Access Compliance Report

Public Rights-of-Way

Intersection ID: 27288	Main Street: PIPER_STATION_DR	Cross Street: REA_RD	Location: SW
ADA ID: 035C69FA8EAB	Ramp Type: PerpDiag	Initial Pass/Fail: Fail	Overall Compliance: No
Codes/Mitigation Info/Possible Solution		Field Measurements/Component Compliance	
Severity Score: 37.5

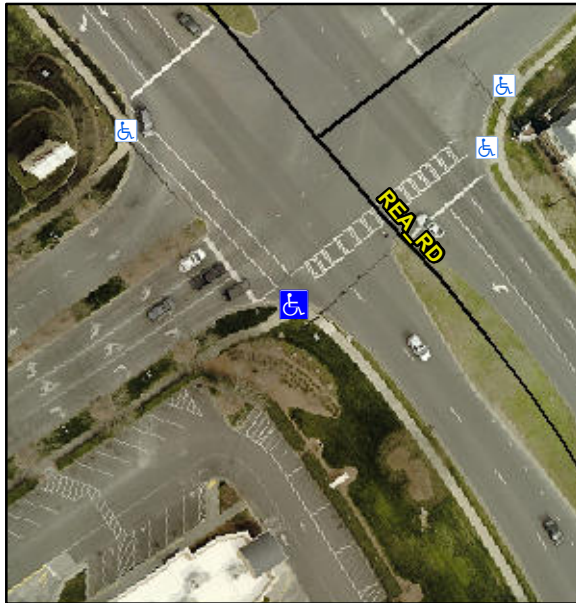
Not Found, R304.2.2, R304.5.3

Compliance	Description	Data	Compliance	Description	Data
N/A	Ramp Length (in)	72.0	No	Ramp Slope (%)	15.0
Yes	Ramp Width (in)	48.0	No	Ramp XSlope (%)	5.9
N/A	Flare Type LT	N/A	N/A	Flare Type RT	N/A
N/A	Flare Slope LT (%)	N/A	N/A	Flare Slope RT (%)	N/A
N/A	Flare Traversable LT?	N/A	N/A	Flare Traversable RT?	N/A
N/A	Landing Length (in)	N/A	N/A	DWS Provided?	N/A
N/A	Landing Width (in)	N/A	N/A	DWS Contrast?	N/A
N/A	Landing Slope (%)	N/A	N/A	DWS Length (in)	N/A
N/A	Landing X Slope (%)	N/A	N/A	DWS Full Width?	N/A
N/A	Landing Curb? (Y/N)	N/A	N/A	DWS Offset (in)	N/A
N/A	Shared Landing?	N/A			
N/A	Gutter Ponding?	N/A	N/A	Gutter Slope (%)	N/A
N/A	Gutter Lip Ht (in)	N/A	N/A	Gutter X Slope (%)	N/A
N/A	Painted X Walk1?	Yes	N/A	Painted X Walk2?	Yes
	X Walk 1 Direction	To NE		X Walk 2 Direction	To NW
N/A	X Walk 1 Width (in)	108.0	N/A	X Walk 2 Width (in)	105.0
	X Walk 1 Slope (%)	1.1		X Walk 2 Slope (%)	1.9
	X Walk 1 X Slope (%)	3.7		X Walk 2 X Slope (%)	3.9

N/A	Ramp inside XWalk1?	Yes	N/A	Ramp inside XWalk2?	No
	Road Slope (%)	5.7	N/A	Clear Space?	N/A
	Road X Slope (%)	1.6	N/A	Clear Space to XWalk (in)	N/A
N/A	Any Obstructions?	N/A	N/A	Storm Grate/Utility Hazard?	N/A
	Obstruction Type			Storm Grate/Utility Type	
		N/A			N/A
		Yes		Surface Condition? (G/P)	Good

Remove & Replace Curb Ramp With Two New Directional Ramps or Equivalent. Restripe Crosswalk.
